KAIZEN CARD

AREA	BMW	Plant:	TUPELO USA
KAIZEN THEME	Not Seating Clip Cramp

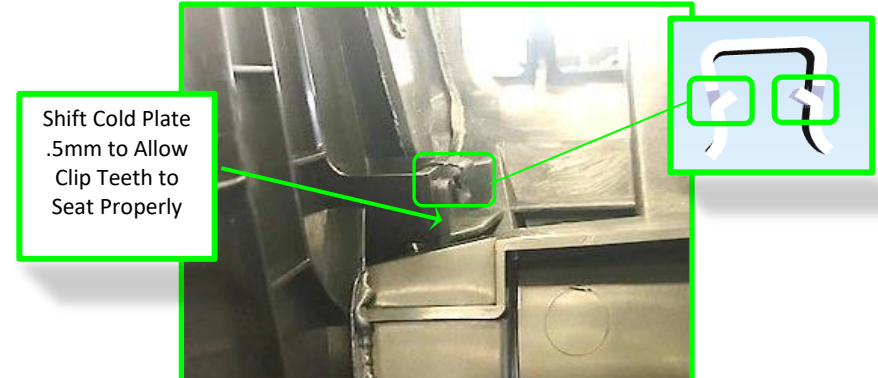
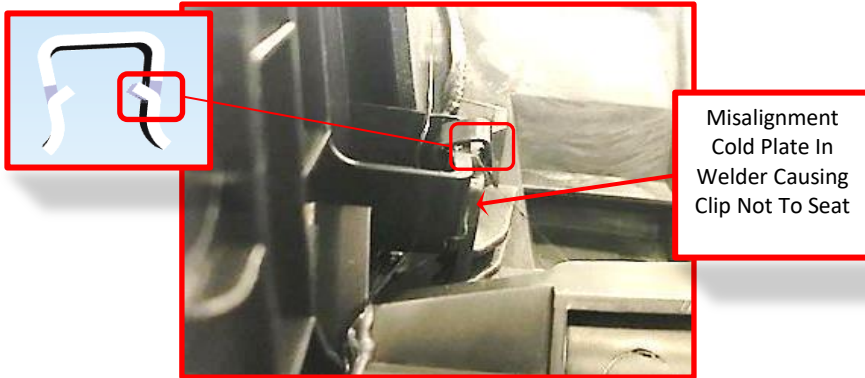
Before Kaizen Description:	Misalignment in cold plate to carrier causing clip cramp not to properly seat. (Minimized weld/pull test force)
-----------------------------------	---

After Kaizen Description:	Modification to cold plate (.5mm) to allow clip cramp teeth to fully seat to carrier and upper side panel. (Maximized weld/pull test force)
----------------------------------	---
